**Technical Review Committee
Conference Call Directions
September 8, 2021 Meeting**

**WORCESTER COUNTY TECHNICAL REVIEW COMMITTEE
AGENDA**

TRC PROJECT REVIEW TRANSMITTAL
Sketch Plan Submission (September 8, 2021 TRC Meeting)

TRC PROJECT REVIEW TRANSMITTAL
Major Site Plan Review (September 8, 2021 TRC Meeting)

Preliminary Site Plan
36 PARKING SPACES
12 CAR STACKING

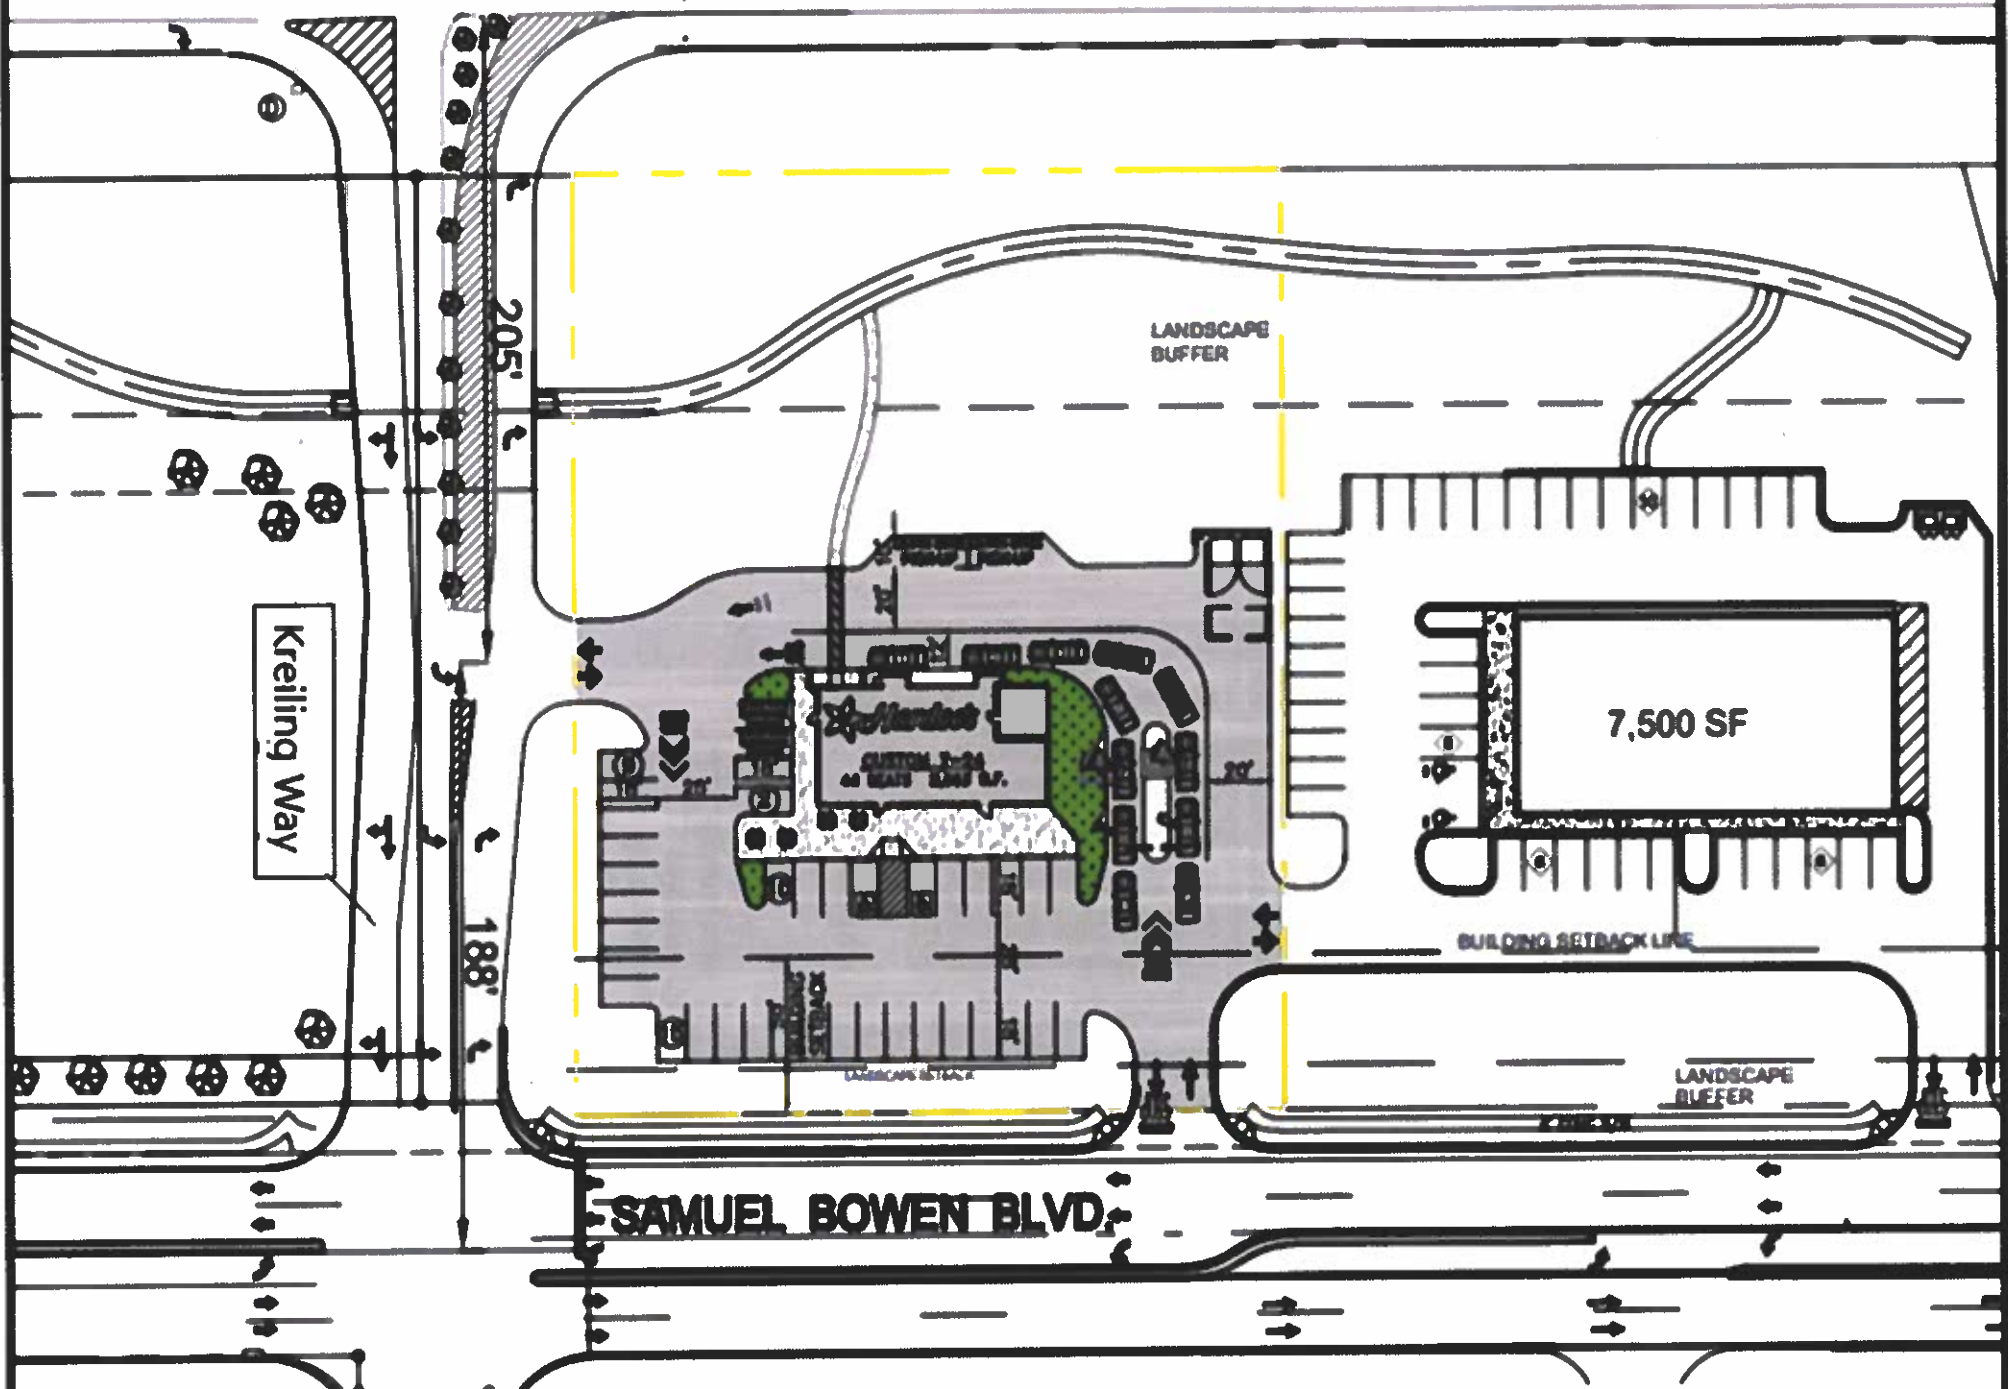
1. Please provide landscaping along western edge of site along Kreiling Way. See ZS1-322.
2. Please provide a bike rack capable of holding at least five (5) bikes. See Zs1-320(e)(12).
3. A loading zone will be required per section ZS1-321.
4. Please show parking calculations on the site plan. See ZS1-320.
5. Parking spaces must be 10' x 20' per ZS1-320(b).
6. Please provide vegetative break between sets of parking spaces greater than 10 consecutively.
7. Indicate what the circular blobs just south of the main building are on the site plan.
8. If lighting is to be proposed, please show on the site plan along with a lighting plan. See ZS1-322.
9. Show dumpster screening typical on the site plan set.

This site plan proposes the construction a new Hardee's restaurant with a new access point on Kreiling Way. District 1 has determined that the proposed access point has a corner clearance of approximately 150' from the intersection of Kreiling Way and US 50, measured from the Point of Tangent at US 50 to the Point of Curvature for the proposed access point. MDOT SHA requires a minimum of 200' of corner clearance from a primary roadway. For this reason, MDOT SHA is denying the request for an access point on Kreiling Way.

SITE PLAN
ZOOM CAR WASH
LOT 3B, GRID 2, PARCEL 455, TAX MAP 26
THIRD TAX DISTRICT BERLIN WORCESTER COUNTY, MARYLAND
J. W. S. S. III ENGINEERING, INC.
P.O. BOX 379, 9842 MAIN STREET, SUITE 3
BERLIN, MD 21811
SCALE: 1" = 30'
DATE: AUG. 2021
DRAWING No.: 471-01-003
SHEET No.: 3 of 7

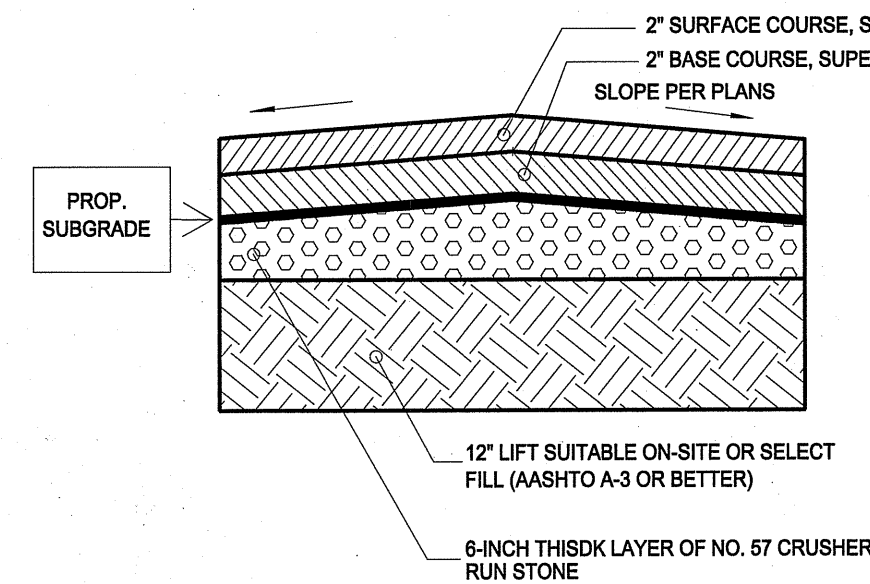
Basic Site Plan Corrections Required:

1. In accordance with §ZS 1-325(e)(3)(R), please add owner's and plan preparer signature blocks. Please include "As the property owner / developer, I am in full agreement with this site plan submitted herewith and I am responsible for the completion of the improvements as shown on the approved site plan, and I understand that I cannot allow the property or buildings to be occupied until the certificate of use and occupancy has been issued by the Department of Development, Review, and Permitting" in the owner's signature block.

2. Please note the method of irrigation on the plan. See §ZS1-322(b)(7).
3. Please verify that the source of water for irrigation will be from an on-site irrigation well.

6. The applicant may wish to reconsider the placement of the 5 parking locations immediately adjacent to the Samuel Bowen Blvd. entrance as this may cause difficulty with vehicles backing up.
7. Is there any particular plans for outdoor furniture/landscaping in the 'patio' area?
8. Please show dumpster enclosure typical.
9. For the voice activation of the members touch-pads, staff is curious as to the noise level that these machines produce.
10. Please consider adding stop signs to western portion of the site near the interparcel connector to Calvin B. Taylor Bank.
11. Show the dimensions of the loading zone.
12. Please indicate the contents of the vending machines.

DATE 11/30/2020
REV. DATE 7/7/2021
DRAW BY
CHK'D BY RD. HAND
DRAWING S-1
SCALE 1"=30'

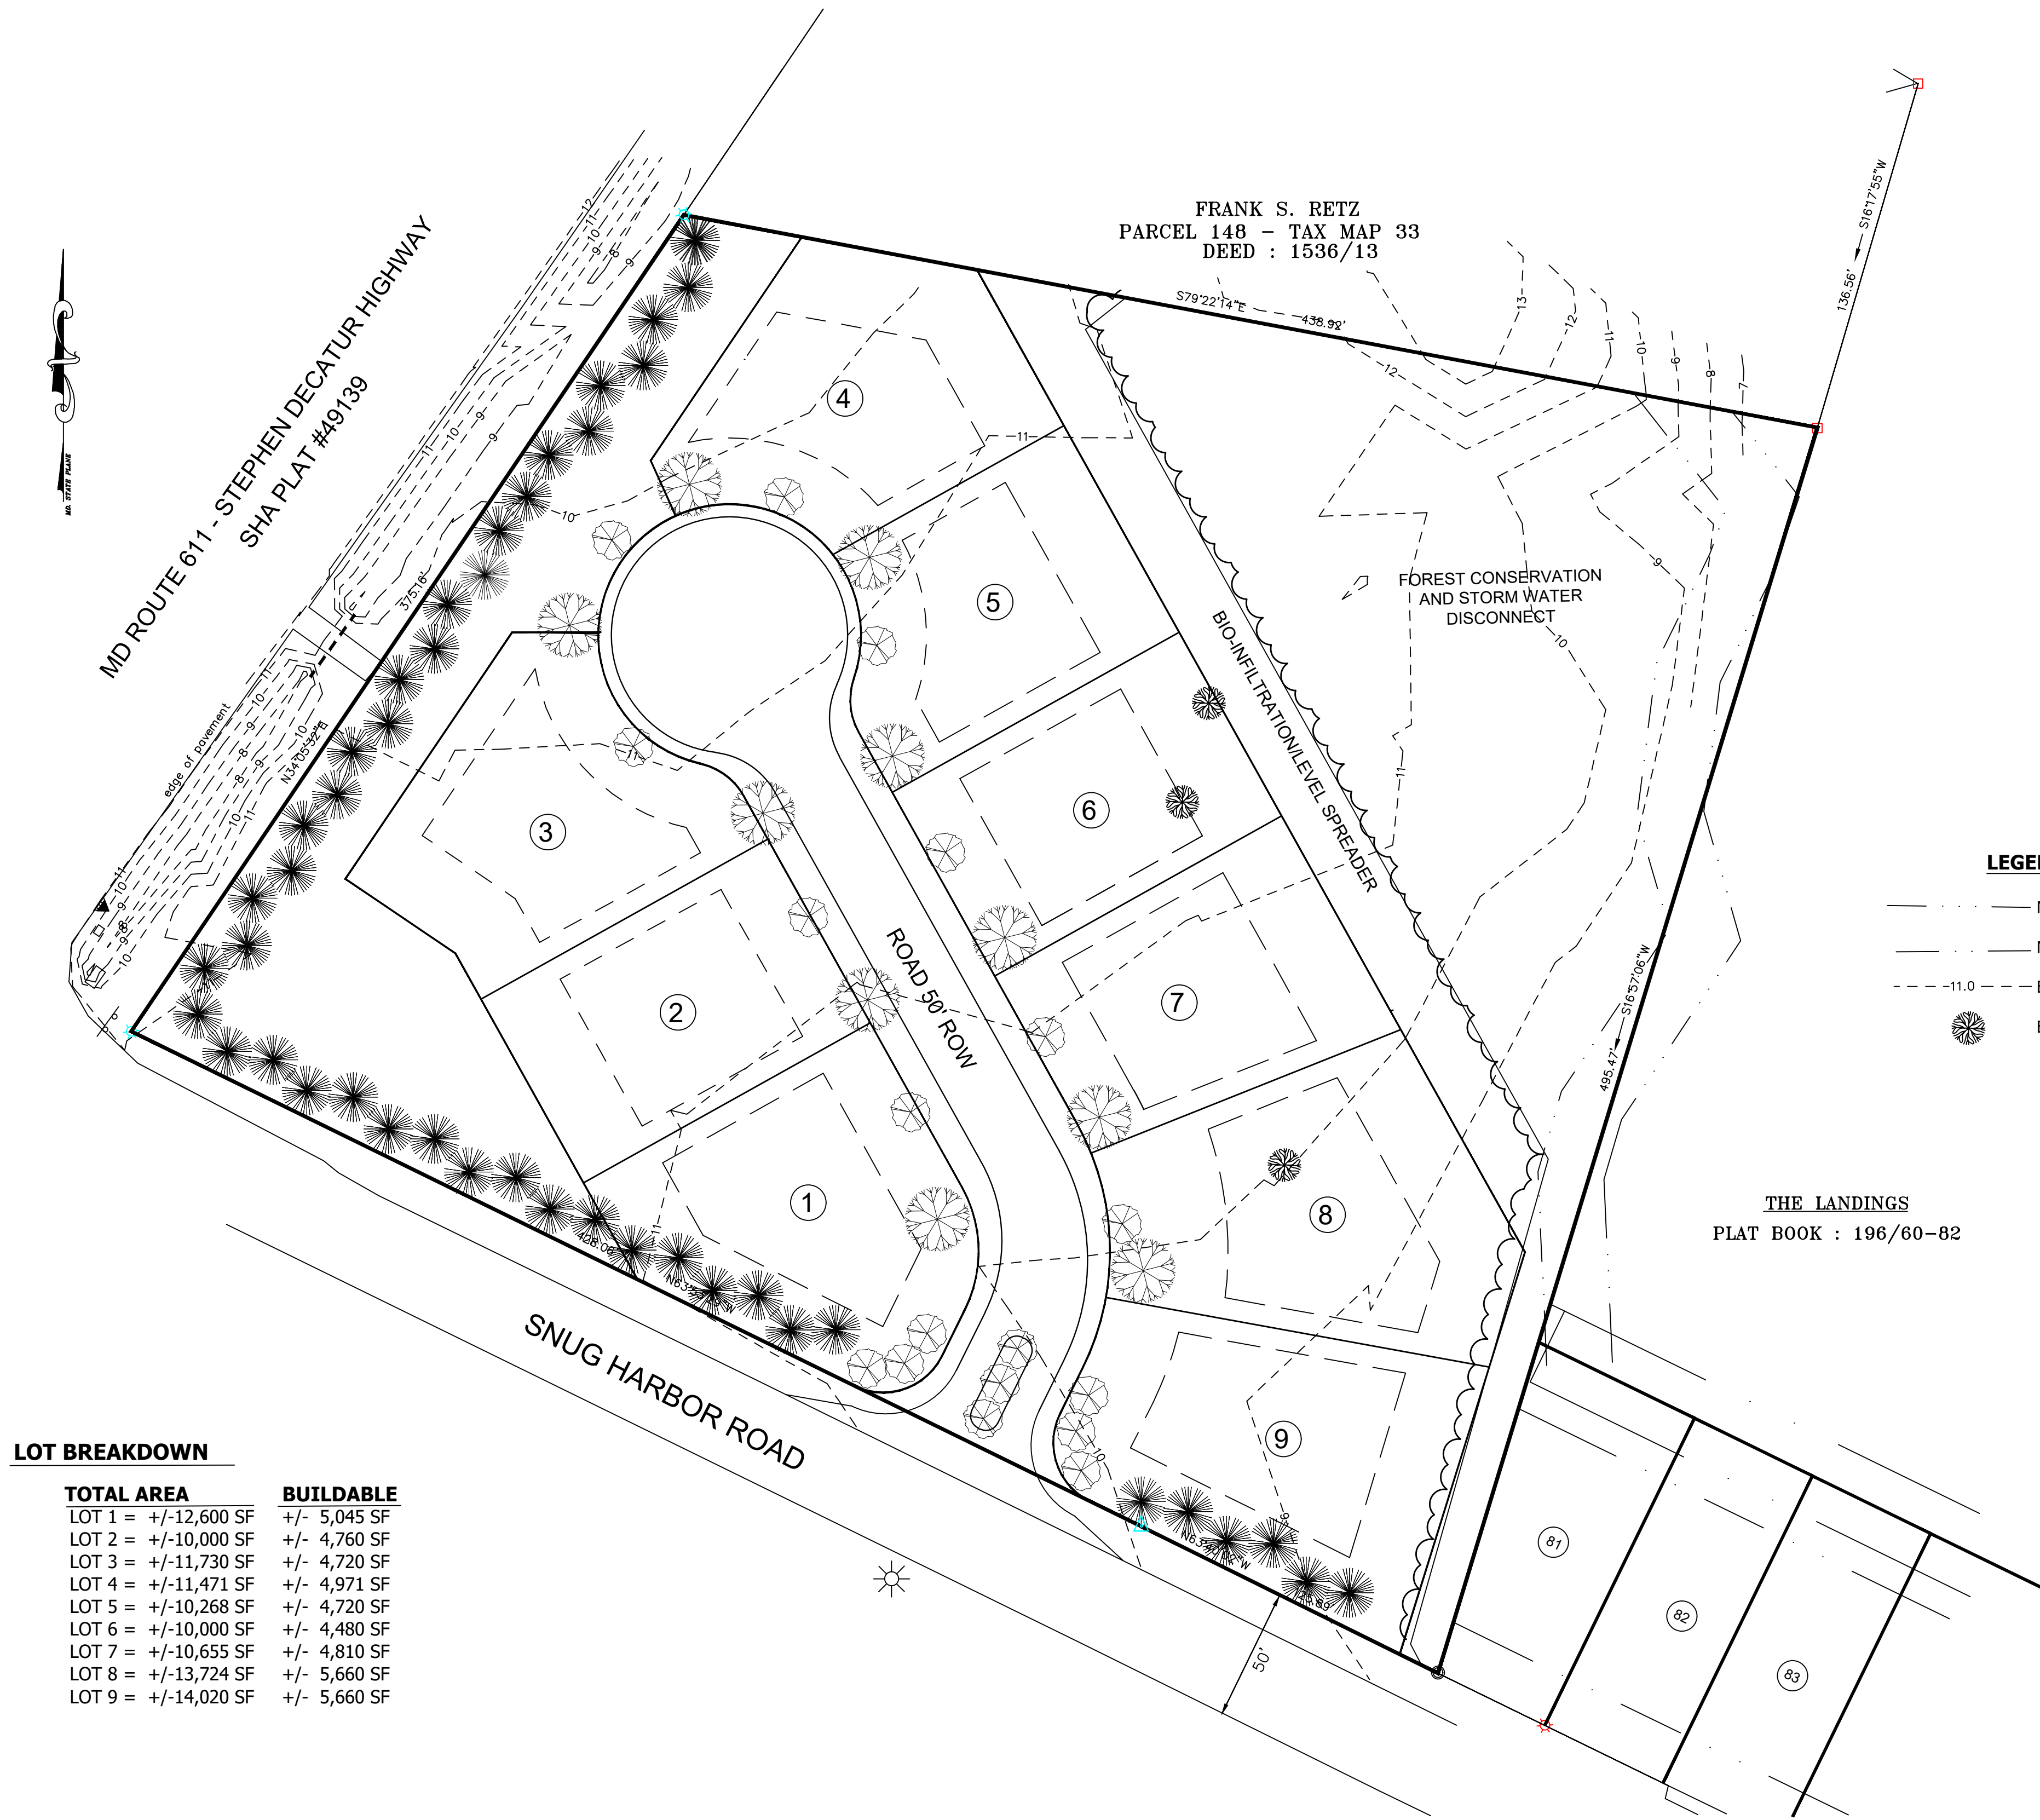
1. Please label the revised site plan as: ‘Step I Minor Residential Planned Community (RPC).’
2. Please label the western portion of the proposed undeveloped areas as open space if that is desired.
3. During the Step II approval process, it is recommended that the applicants supply a landscaping plan indicating the number any type of species that will be used for landscaping.
4. Also, during the Step II approval process, please indicate the maximum heights of the dwellings in accordance with ZS1-315(h).
5. **Please note that the Planning Commission shall determine the lot requirements as part of their Step II review.*
